SERVICE INFORMATION LETTER

OXYGEN (ATA SYSTEM 35)

TO: ALL OPERATORS UTILIZING SCOTT AVIATION PROTECTIVE BREATHING EQUIPMENT (PBE) P/N 802300-14

SUBJECT: AVAILABILITY OF AN INFORMATION LABEL INTENDED TO PREVENT INADVERTENT MIS-INSTALLATION OF OPTIONAL CONTAINER ASSEMBLY P/N 803436-02, FOR THE SCOTT AVIATION PBE.

Container Assembly
P/N 803436-02
(Shown with PBE)
Figure 1

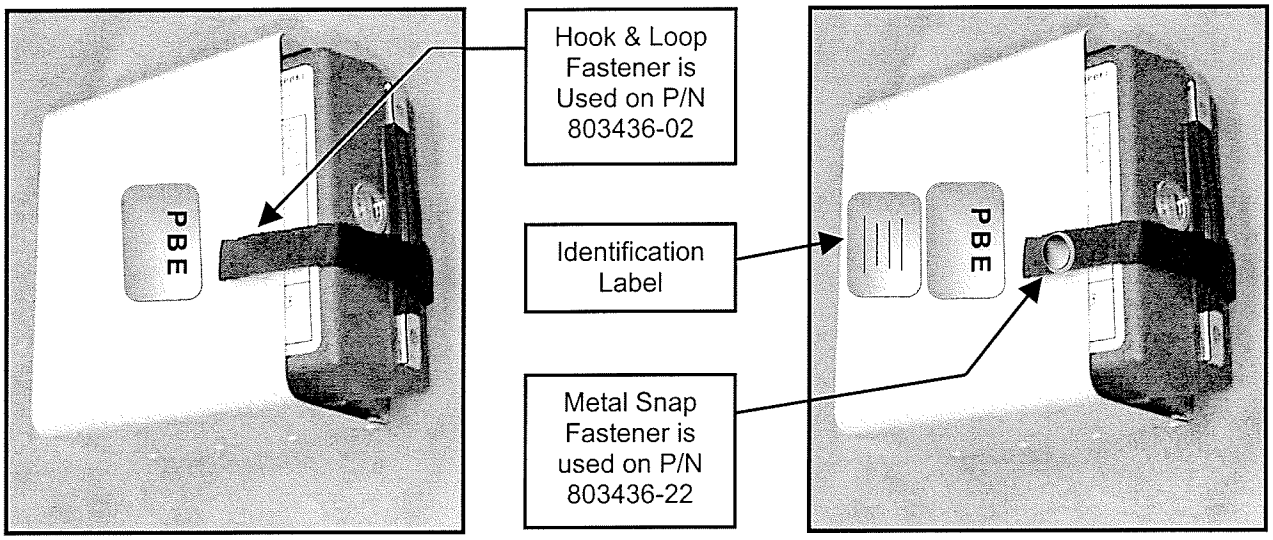
This Service Information Letter is to remind aircraft operators that optional Container Assembly P/N 803436-02 **IS NOT** an independent stowage compartment, and to make available an Information Label for the Container Assembly to prevent it from inadvertently being mis-installed.

Container Assembly P/N 803436-02 is intended to be mounted as a divider inside a closeable stowage compartment meeting the requirements of FAA regulation 14 CFR paragraph 25.787.

If it is required to place a Scott PBE in a passenger or crew compartment or a galley, use Scott Stowage Compartment Assembly P/N 803436-22. When properly approved for installation in a specific aircraft or aircraft type, the Scott stowage compartment is capable of meeting the requirements of FAA 14 CFR paragraph 25.787. See Figure 2.

Information Label P/N 10011185
Figure 3

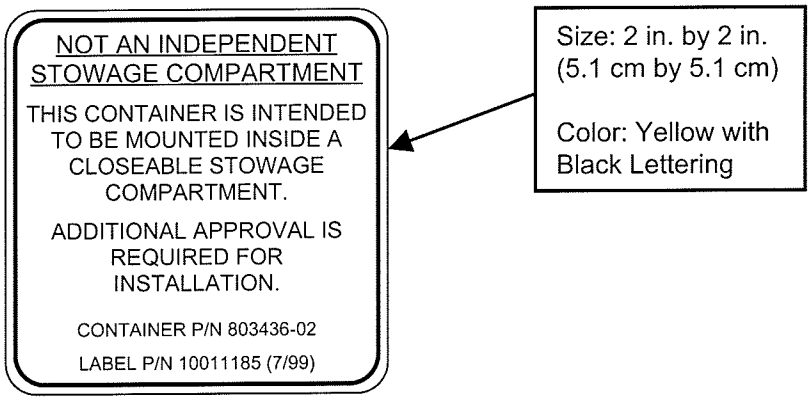
To prevent the inadvertent installation of Container Assembly P/N 803436-02 in a location where Stowage Compartment Assembly P/N 803436-22 should be approved for use, Scott is making available Information Label P/N 10011185. Information Label P/N 10011185 is to be applied to the exterior of all Container Assemblies P/N 803436-02, both those installed in aircraft and those in storage for future use. See Figure 3.

Information Label P/N 10011185 is available free of charge from Scott Aviation for use on Container Assembly P/N 803436-02. Only the Information Label obtained from Scott Aviation is to be used. No reproduction Label may be used. See below for how to contact Scott Aviation to obtain Information Labels.

If it is determined that a Container Assembly P/N 803436-02 has been inadvertently installed in a location that requires a stowage compartment meeting the requirements of FAA 14 CFR paragraph 25.787, it is recommended that first the PBE be removed from the Container Assembly. Then the Container Assembly must be removed from its present location, and approval obtained from the cognizant authority for reinstallation of the Container Assembly inside a closeable stowage compartment. If this is not possible, then contact Scott Aviation as shown below to arrange for the remanufacture of the Container Assembly P/N 803436-02 into a Stowage Compartment Assembly P/N 803436-22, or for the purchase of a new Stowage Compartment Assembly P/N 803436-22 for the original location. Note that it is the responsibility of the installer to obtain the necessary approvals for installation in an aircraft.
